# Access Compliance Report

## Public Rights-of-Way

### (Curb Ramps)

Intersection ID: 50590	Main Street: GREEN_GRASS_RD	Cross Street: SITKA_CT	Location:	N
ADA ID: B272E13FAA36	Ramp Type: Perp	Initial Pass/Fail: Fail	Overall Compliance: No	Severity Score: 12.5
Codes/Mitigation Info/Possible Solution		Field Measurements/Component Compliance

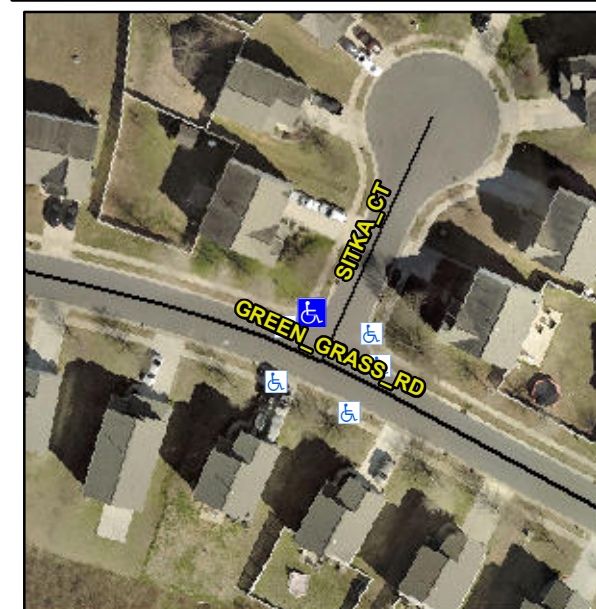
**Not Found, R304.5.3**

Compliance	Description	Data	Compliance	Description	Data
N/A	Ramp Length (in)	48.0	Yes	Ramp Slope (%)	5.9
Yes	Ramp Width (in)	48.0	No	Ramp XSlope (%)	6.2
N/A	Flare Type LT	N/A	N/A	Flare Type RT	N/A
N/A	Flare Slope LT (%)	N/A	N/A	Flare Slope RT (%)	N/A
N/A	Flare Traversable LT?	N/A	N/A	Flare Traversable RT?	N/A
N/A	Landing Length (in)	N/A	N/A	DWS Provided?	N/A
N/A	Landing Width (in)	N/A	N/A	DWS Contrast?	N/A
N/A	Landing Slope (%)	N/A	N/A	DWS Length (in)	N/A
N/A	Landing X Slope (%)	N/A	N/A	DWS Full Width?	N/A
N/A	Landing Curb? (Y/N)	N/A	N/A	DWS Offset (in)	N/A
N/A	Shared Landing?	N/A			
N/A	Gutter Ponding?	N/A	N/A	Gutter Slope (%)	N/A
N/A	Gutter Lip Ht (in)	N/A	N/A	Gutter X Slope (%)	N/A
N/A	Painted X Walk1?	No	N/A	Painted X Walk2?	N/A
	X Walk 1 Direction	To SE		X Walk 2 Direction	N/A
N/A	X Walk 1 Width (in)	N/A	N/A	X Walk 2 Width (in)	N/A
	X Walk 1 Slope (%)	0.7		X Walk 2 Slope (%)	N/A
	X Walk 1 X Slope (%)	4.2		X Walk 2 X Slope (%)	N/A

**Remove & Replace Entire Ramp.**
